U.S. Geological Survey

May 6, 2010

Subject: USGS responses to issues raised by the Technical Memorandum, "Review and reevaluation of Skagit River 1921 flood peak discharge."

The following text summarizes the USGS responses to specific issues raised by the Technical Memorandum, "Review and reevaluation of Skagit River 1921 flood peak discharge," that was distributed at our March 17 meeting. (*Responses from the Cities of Burlington and Mount Vernon shown in italicized blue font*)

Stewart's field notes, pp. 30-31

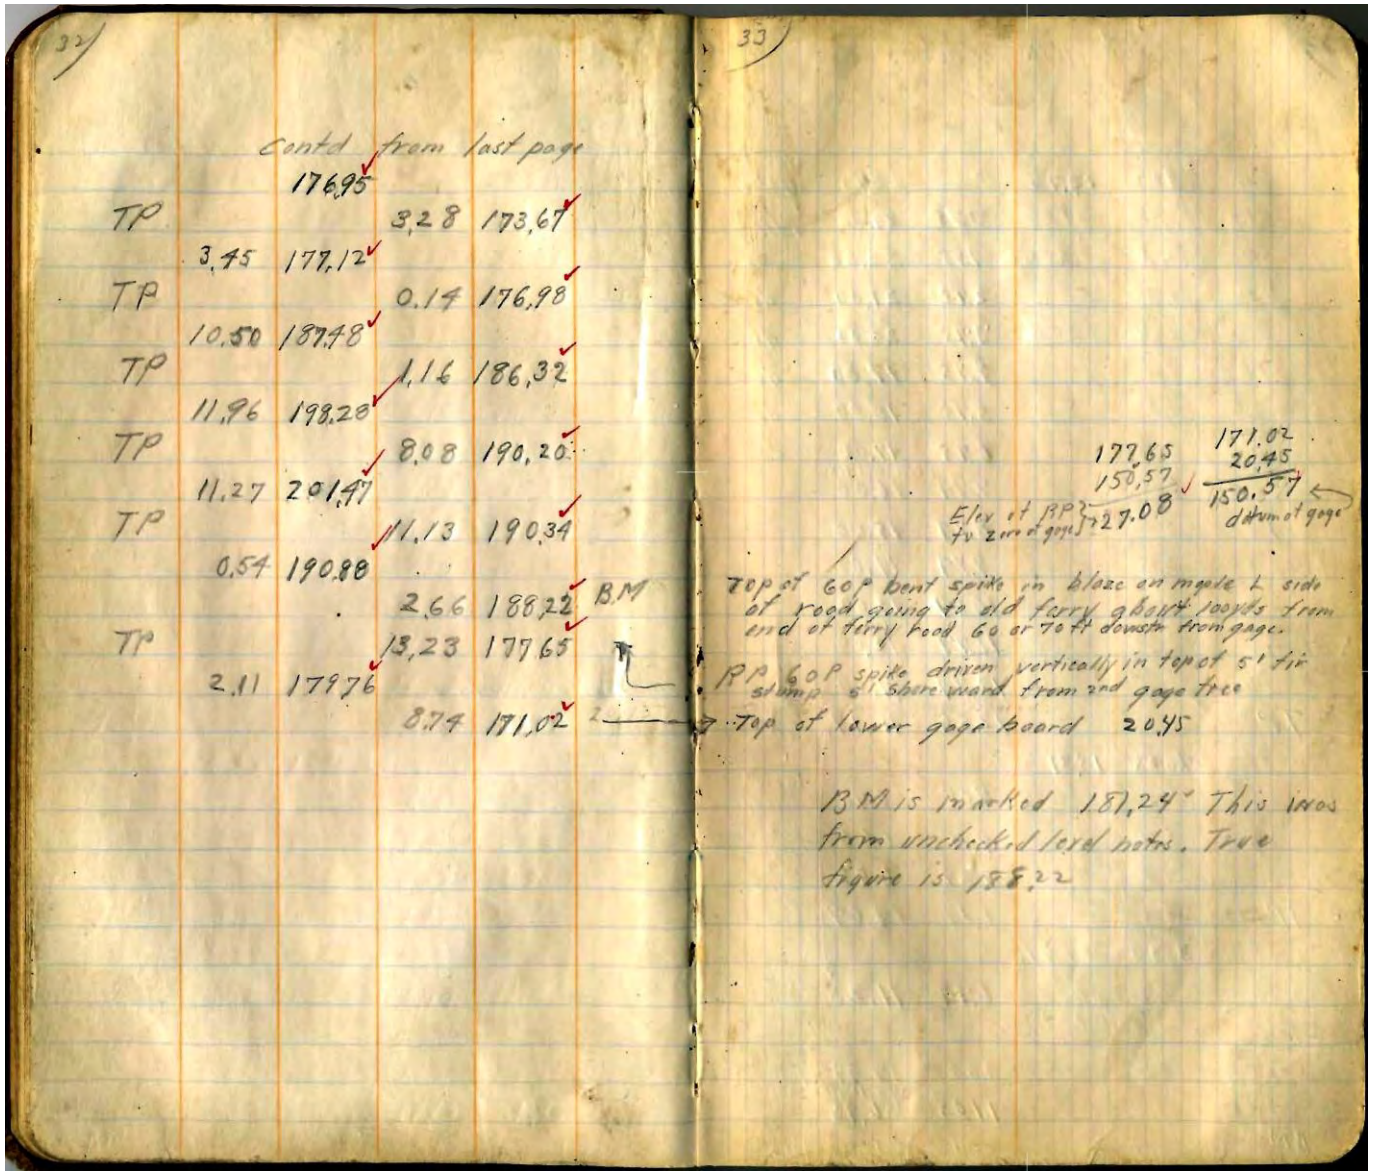
On December 22nd, 1922, Stewart began the survey from the USGS benchmark located in Concrete and referenced in a USGS publication at the time (Bulletin 674, Spirit Leveling in the State of Washington, 1897 to 1917, Inclusive). This survey is documented on pp. 30-33 of Stewart's field notes. The survey proceeded from the USGS benchmark to the old Ferry Landing downstream of the Crofoot's Addition in Concrete. There Stewart set a benchmark at 188.22 feet msl and also set a reference point at 177.65 feet msl, as well as providing a reference to the gage he located there, noting "Top of lower gage board 20.45" equated to a msl elevation of 171.02. See the following figures, pp. 8-9:

Stewart's field notes, pp. 84-85

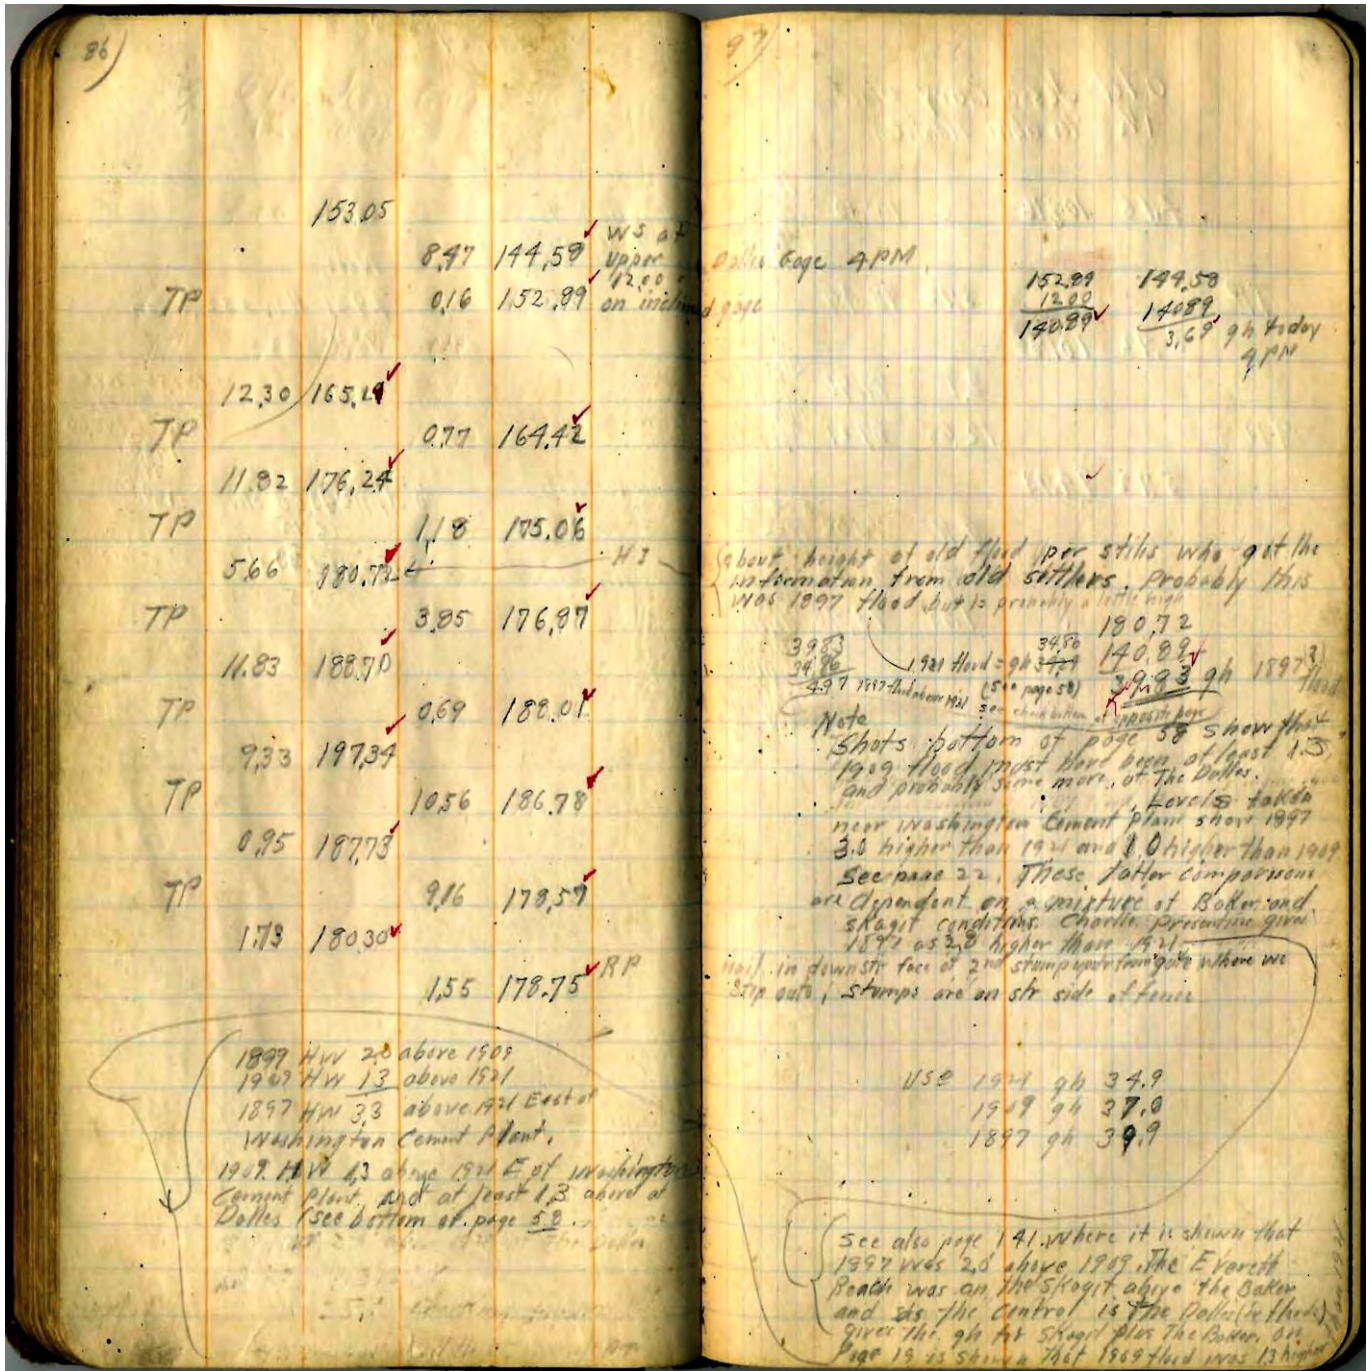
Stewart then proceeded downstream through 9 turning points to the Upper Dalles gage, where he calculated the Upper Dalles gage datum, based on a gage reading of 12.00 equating to an elevation of 152.89 feet, giving a gage datum of 140.89 feet. Stewart then proceeded on downstream through 6 turning points to the Lower Dalles gage, where he set a reference point at elevation 178.75. See the following figures on pp. 11-13:

Stewart's field notes, pp. 64-65

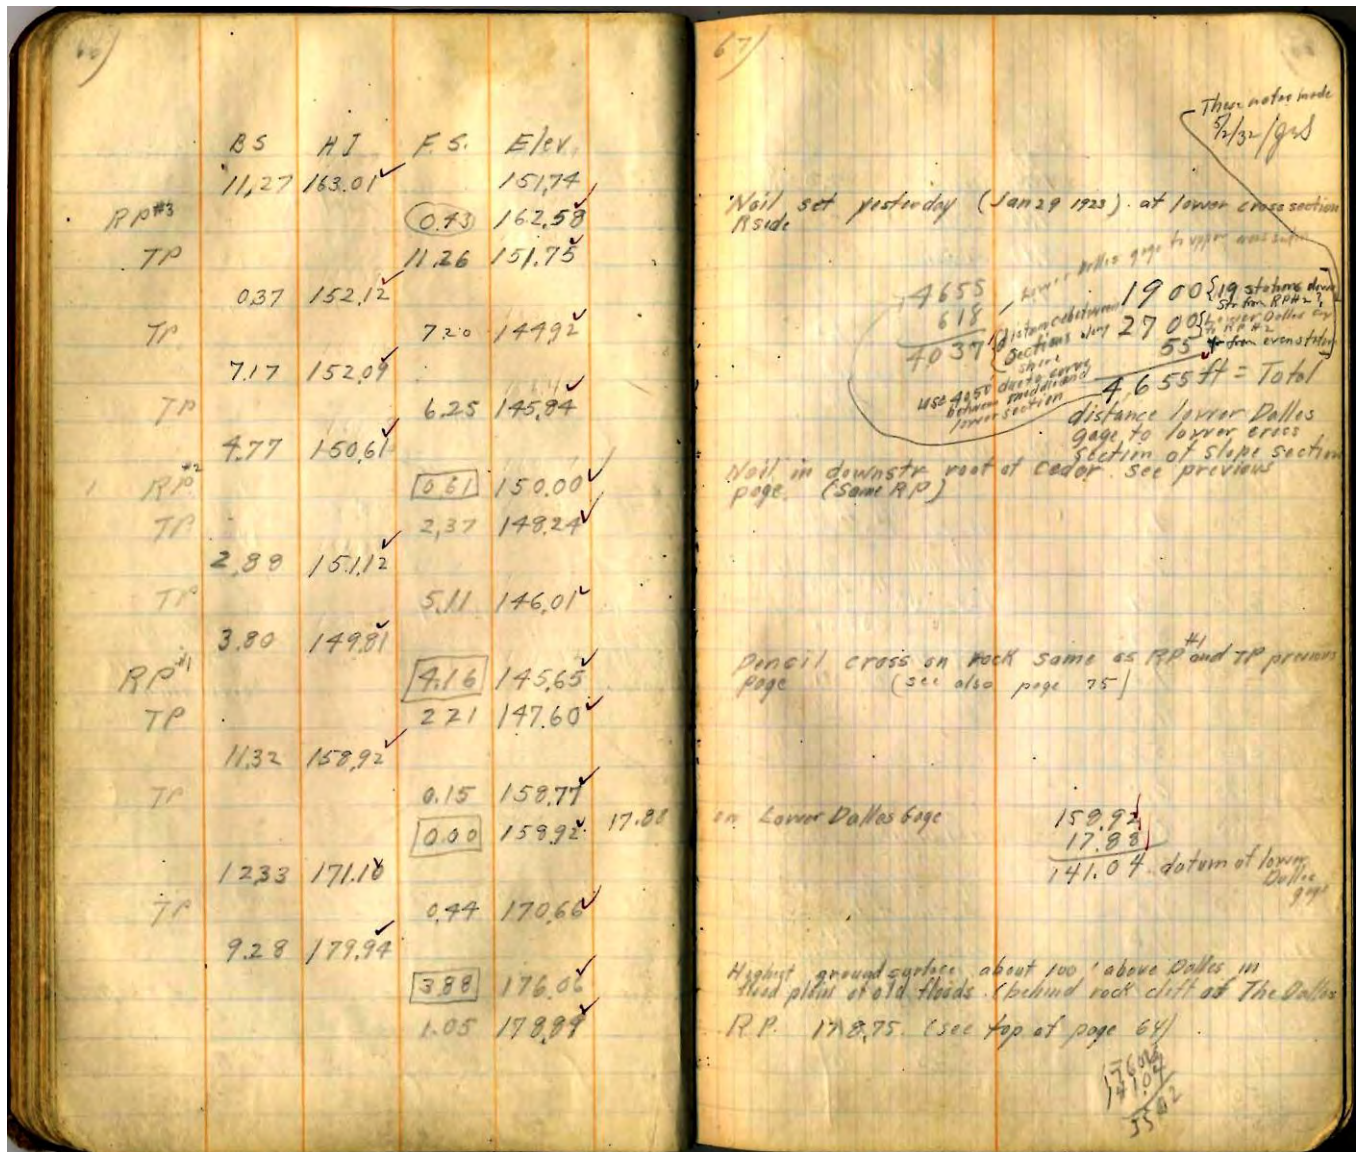
Cities' Comment: On January 30th, Stewart surveyed from the Upper Dalles gage to the lower slope section, and back. During this survey he established the datum for the Lower Dalles gage. This survey closed to within 14/100ths of a foot at the reference point Stewart had established at the Upper Dalles gage. See below:

Figure 3. Slope Section XS3 - Skagit River near Concrete, WA

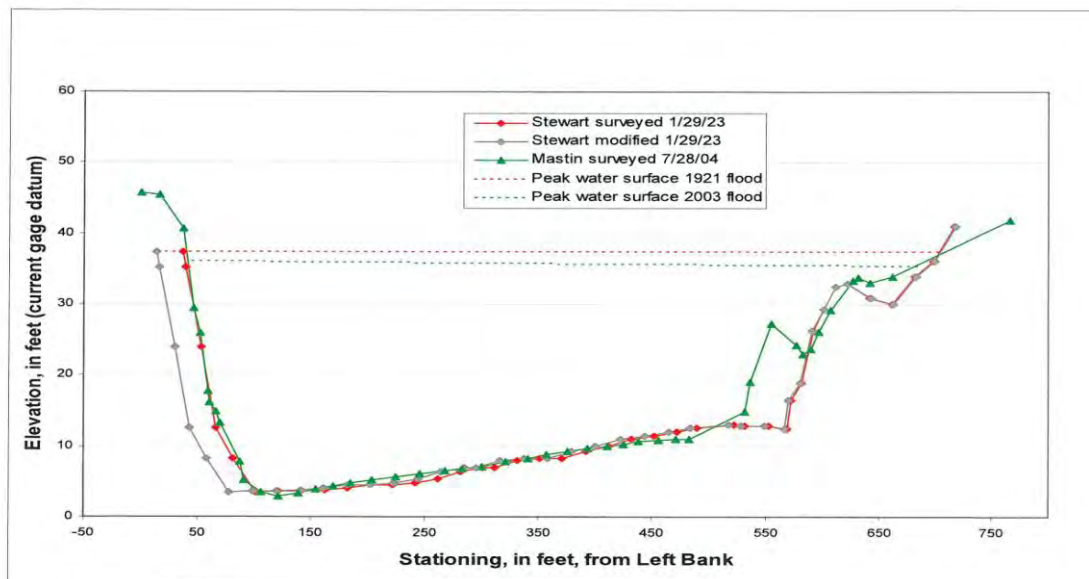
Cities' Comment: *Compelling evidence to adjust the cross sectional area of the lower slope section comes from the USGS' cross section measurements at Stewart's furthest downstream cross section. The following figure overlays Stewart's cross section with a cross section developed by USGS in 2004:*

As the overlaid surveys demonstrate, this cross section has remained nearly the same over the years, especially along the left bank, and Stewart's adjustments for this lower cross section as

While there are strong similarities between the 2003 Mastin cross-section surveys and the 1921 Stewart surveys, there are clearly significant differences between them, especially near the right bank as indicated in the technical memorandum in figure 3. These differences suggest the very real possibility that the surveys were made at different locations or that the stream cross-sections have changed over the 80 years that have transpired between the surveys.

The USGS acknowledges that Stewart adjusted the cross-sectional width and area for the upper and lower cross-sections. He did report that he was unsure about the precise correction that should be used and he applied the corrections developed for the upstream cross-section to the downstream cross-section measurements. But Stewart did so having first-hand experience with the survey and knowing whether or not the rope had become wet, stretched, and in need of adjustment. Given that a correction was clearly necessary at the upper section and that the same survey techniques and conditions prevailed at both sections, the USGS sees no compelling reason to nullify Stewart's judgment.

Figure 1 -- High-water marks and peak water-surface profiles in the slope-area reach downstream of USGS streamgauge Skagit River near Concrete, WA Station Number 12194000 for the Dec. 1921 and Nov. 2006 floods.

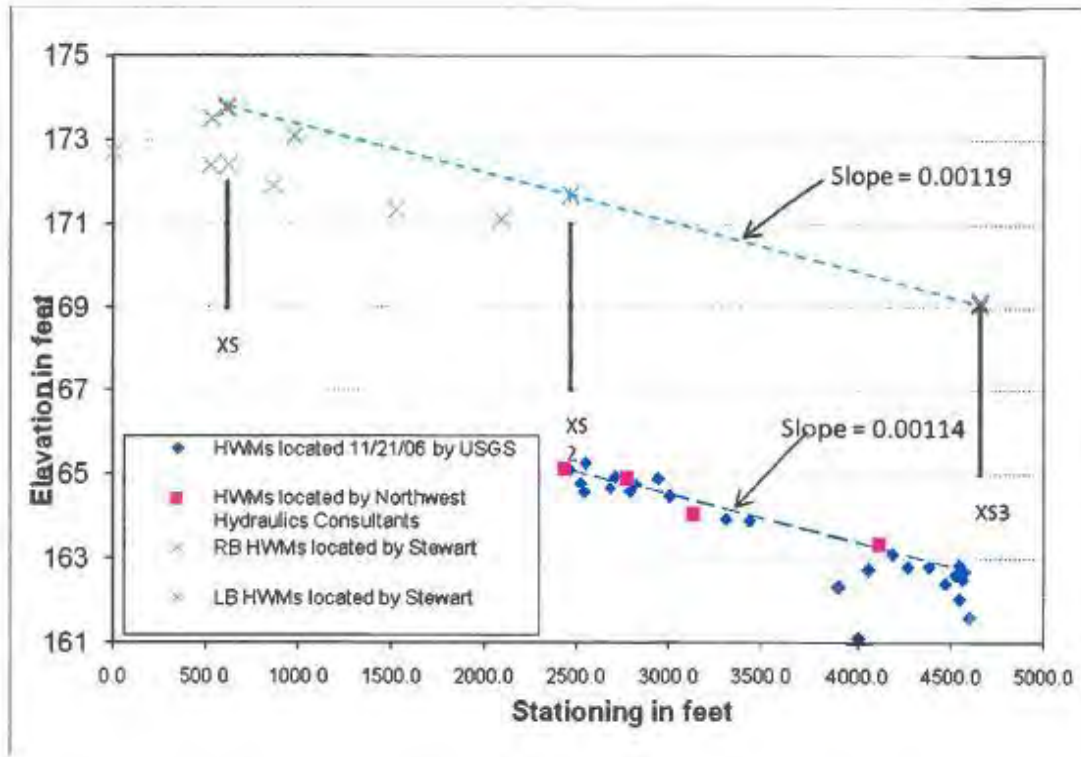
Cities' Comment: *The USGS did not gather any data following the 2006 flood, upstream of XS2. This is a significant weakness, as the USGS only uses the lower slope section to attribute the hydraulic grade line to the entire slope-area reach.*

This is precisely what Stewart did. He emphasized the highest marks, attributing them to the water levels occurring at peak flow and the lower marks to water levels that occurred after the peak. On p. 25 of Stewart's 1923 report, "Floods in Skagit River Basin, Washington" he writes, "When looking for the 1921 crest, there was danger of obtaining a lower point than the flood crest." As such, the five marks that figure most prominently in the development of his surface-water profile were the most reliable estimates of the water profile during the peak flow. Significantly, two sets of marks (those of cross-sections 1 and 3) are confirmed by independent marks found on the opposite bank. Stewart did not blindly extend the profile from cross-section 2 and 3, he had highwater marks at both locations, and in addition to those he had marks along the reach from cross-section 1 and 2. The result was a single, consistent slope of 0.00119 feet/foot.

This slope has also been confirmed by other flood data. In November 2006, soon after a peak of 145,000 ft³/s, the USGS surveyed HWMs between locations approximating cross- sections 2 and 3 and defined a peak water slope of 0.00114 (fig. 1, Mastin 2007). This slope matches to within 3 significant figures the surface-water slope computed by Stewart.

Figure 4. High-water marks (HWMs), flattest- and steepest-sloped water-surface profiles, and a HEC-RAS water-surface profile near cross sections XS1, XS2, and XS3, at Skagit River near Concrete, Washington.

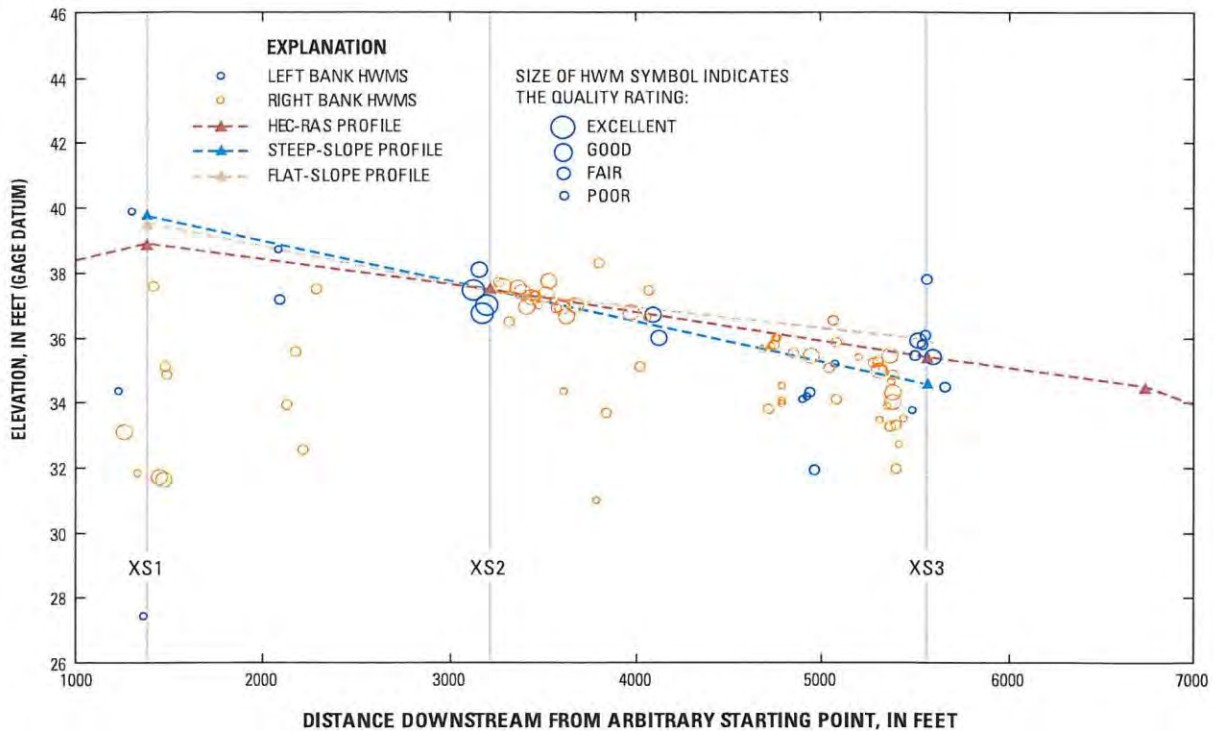
The table below comes from the USGS 2005 report, and contains high water marks collected by the USGS 9-10 months after the October 2003 flood event. Shown below is a profile showing the high water marks surveyed by USGS in the summer of 2004 following the October 2003 flood of record.

Note that the high water marks in the vicinity of cross section XS2 are well clustered, with "good" or "excellent" high water marks within a 2-foot range. The range of high water marks collected by the USGS in the vicinity of XS3 indicate that gathering high water marks in this area was a more difficult task than at XS2. In the case of XS1, it is clear the difficulty of gathering accurate high water marks is very challenging. Note that right bank marks rated "good" are 5-8 feet below the expected water surface elevation.

Aerial view of the Dalles gorge showing current and old gage locations and the locations of Stewart's slope-area cross sections XS1, XS2, and XS3.

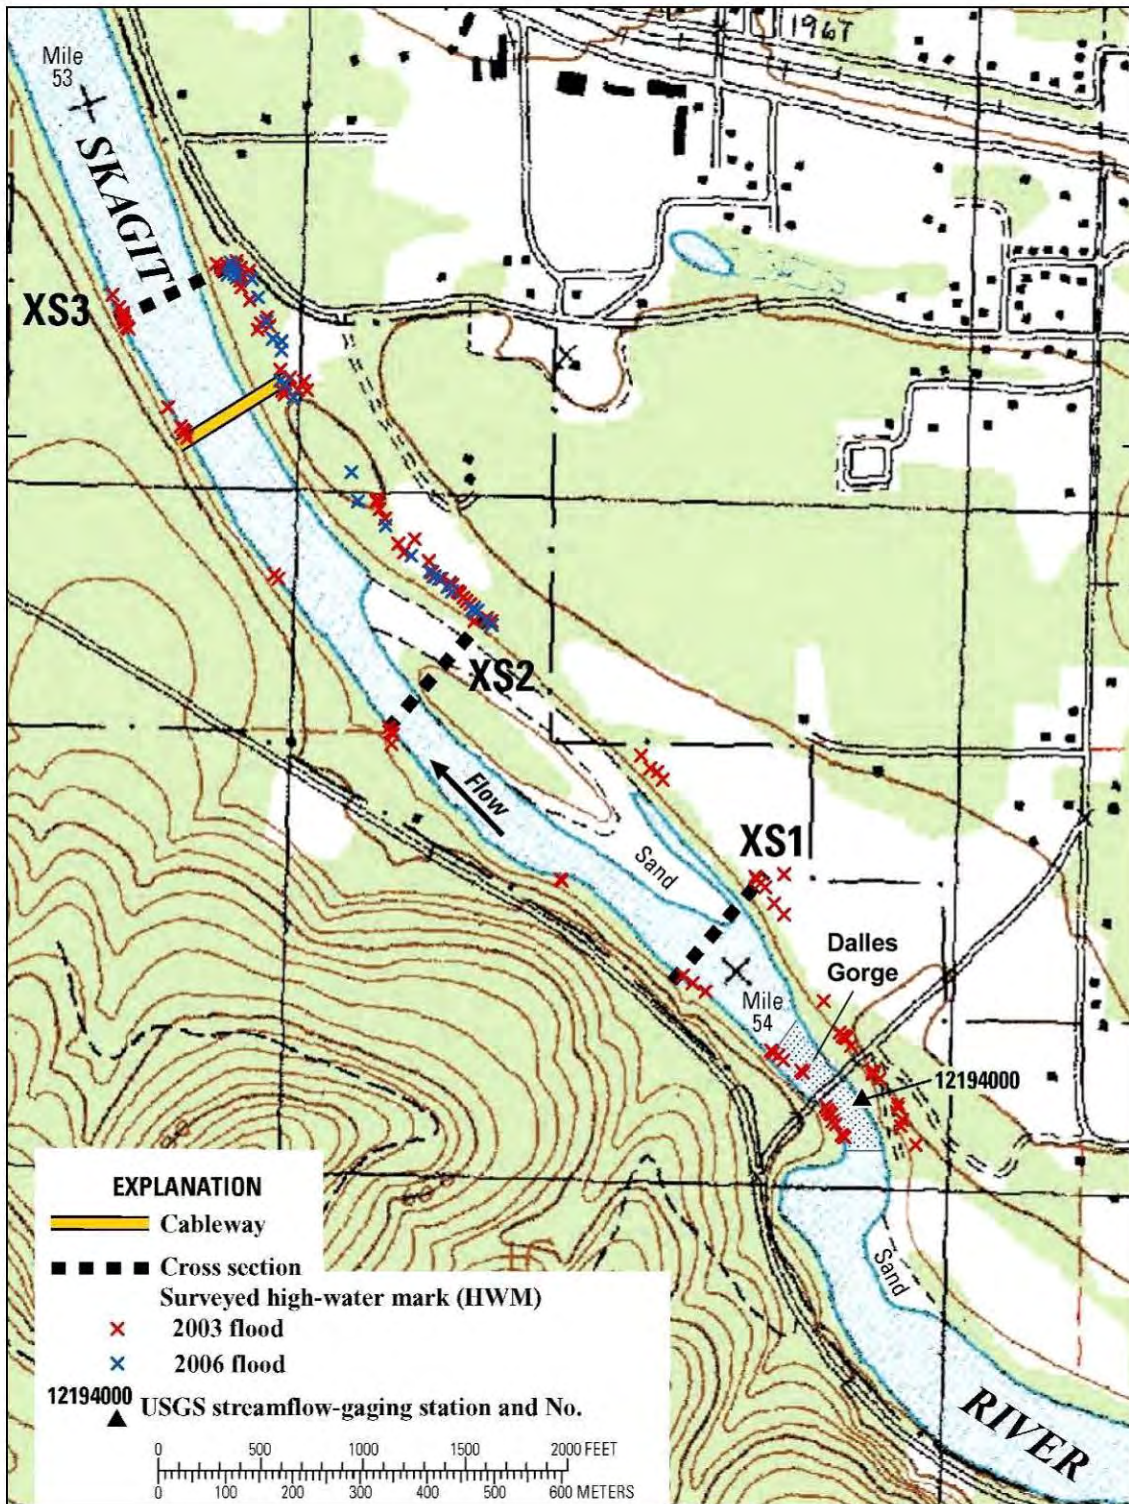
We concur with the slope drawn for the 2006 flood between slope sections XS2 and XS3. However, we observe that the USGS did not attempt to estimate the slope between XS1 and XS2, instead attributing the slope for the entire reach by simply extending the slope obtained from the data from XS2 to XS3. This is unreasonable because the river is expanding between XS-1 and XS-2, and contracting between XS2 and XS3. From the USGS 2007 report, here is a description of the USGS difficulties in collecting accurate high water marks in the vicinity of XS1:

Cities' Comment (continued): Due to the difficulty in collecting accurate high water marks upstream of Stewart's XS2, the USGS in 2006 did not collect any high water marks upstream of XS2. Lack of information regarding the peak flow stage at XS1 is a significant deficiency in a study intended to reconstitute Stewart's approach to estimating the 1921 flood peak discharge. (See PI Engineering, March 2011, sections 2.2.5 and 2.2.6)
